1984 - 1990 Corvette: Service Bulletin: Service Part For Seat Cushion Retaining Wire

Number: 90-154-10

Subject: Service Part For Seat Cushion Retaining Wire

Model Year: 1984-1990 Y Car

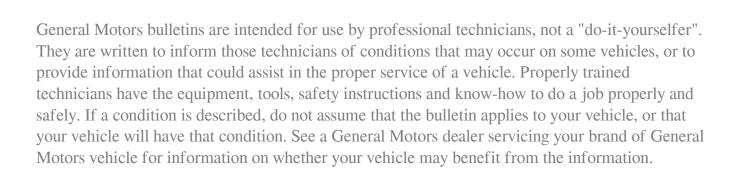
GMSPO has released for service a cushion retainer wire service kit, P/N 10153686. On current and past model Corvettes, it was necessary to replace the seat cushion if the retaining wire broke. With the release of this kit simply replace the wire retainer as outlined below:

- 1. Remove cushion from frame by pushing down on top of cushion and unsnapping wire retainer.
- 2. Using side cufters remove Hartco C-clips from cushion border wire.

1. Position cushion retaining wire legs onto border wire extensions.

IMPORTANT: "J" shape of retaining wire must face toward front of vehicle.

- 2. Place Hartco clips around cushion retaining and foam cushion border wire. Both sides of clip should be visible. If necessary, pull foam slightly away from border wire.
- 3. With pliers, crush outer legs of Hartco clip around both cushion wire and legs of retaining wire. Then crush inner leg around wires. Clip should wrap securely around both wires.
- 4. Reinstall seat cushion to frame by putting cushion retaining wire through hole in frame then pushing down on top of cushion and snapping cushion retaining wire over frame projections.
